## D/DRC Case

2410 Park Street

**DESIGN/DEVELOPMENT REVIEW COMMISSION  
DESIGN REVIEW DISTRICT  
HISTORIC AGENDA  
EVALUATION SHEET  
Case #1**

**NATURE OF REQUEST:** Request for a Certificate of Design Approval for new construction

Proposed right and left elevations with staff recommendations noted

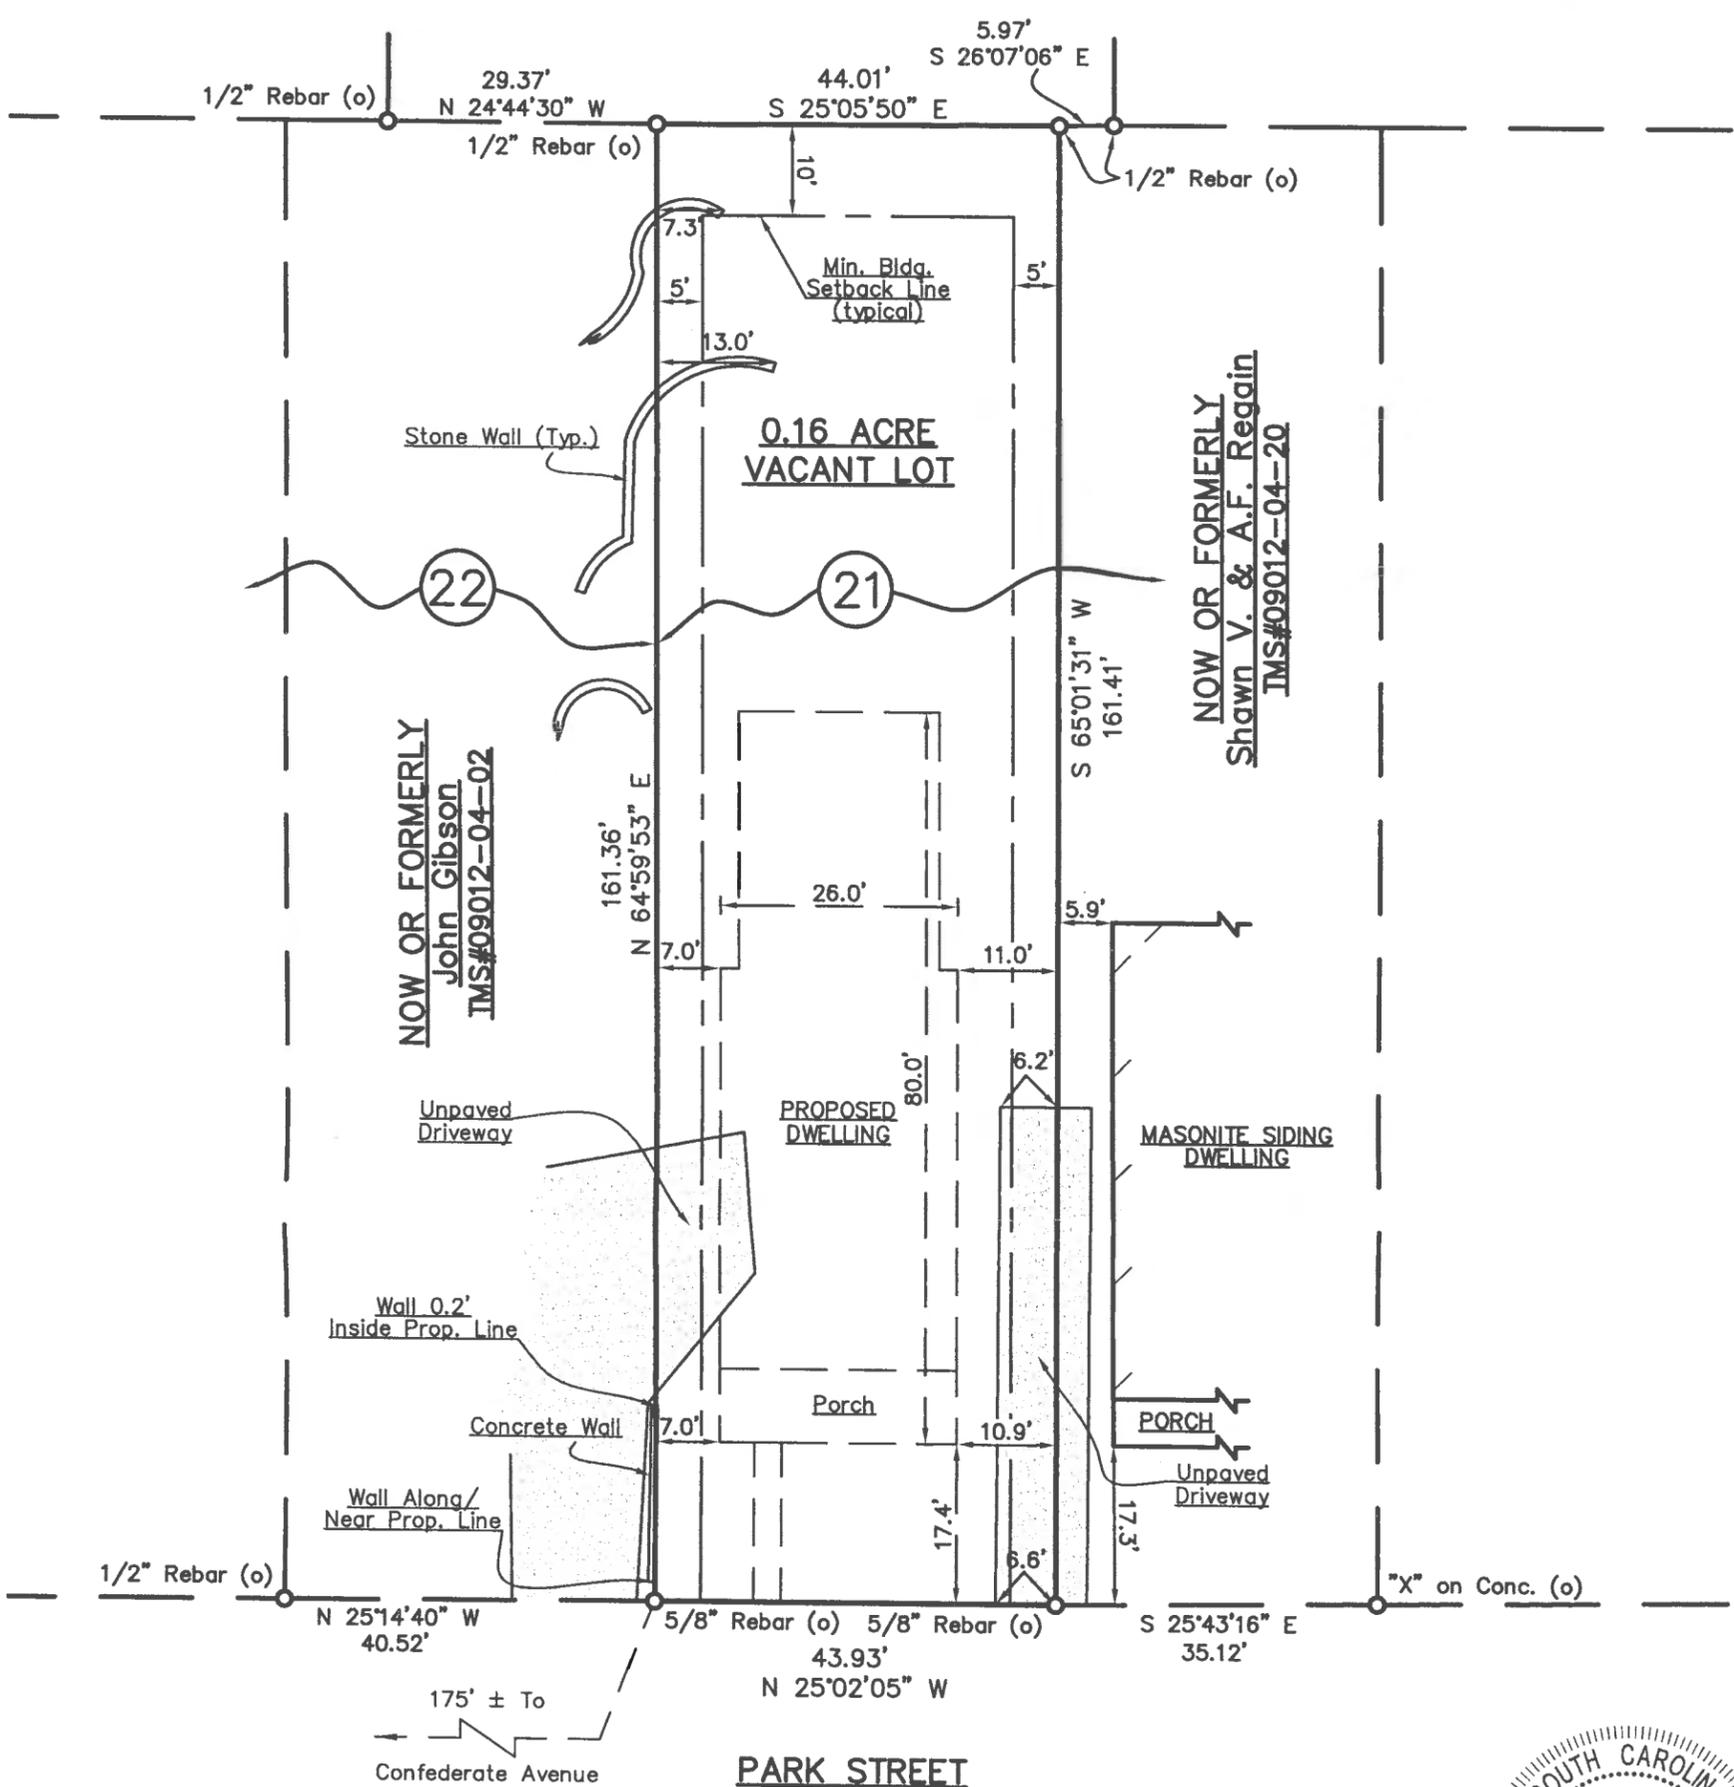
The massing of the proposed house is generally compatible with existing historic buildings on the block or street. The fenestration pattern on the façade and both side elevations is balanced; however, the transoms over the windows on the left and right side first floor windows are not consistent with other historic houses in the district. In general, transom windows are seen above entry doors on some historic buildings in the district, but transoms over windows on side elevations is perhaps nonexistent. There are, however, a number of houses that have art glass above the first floor windows on the façade. Due to this fact, staff can recommend retaining the transom windows above the first floor windows on the façade as proposed, but the transoms over the windows on the side elevations should be removed.

Remove transoms above windows on the first floor of both side elevations

- The front gable shall feature cornice returns or a treatment that is more consistent with similarly styled houses in the district.
- The transoms above the windows on the left and right sides shall be removed.
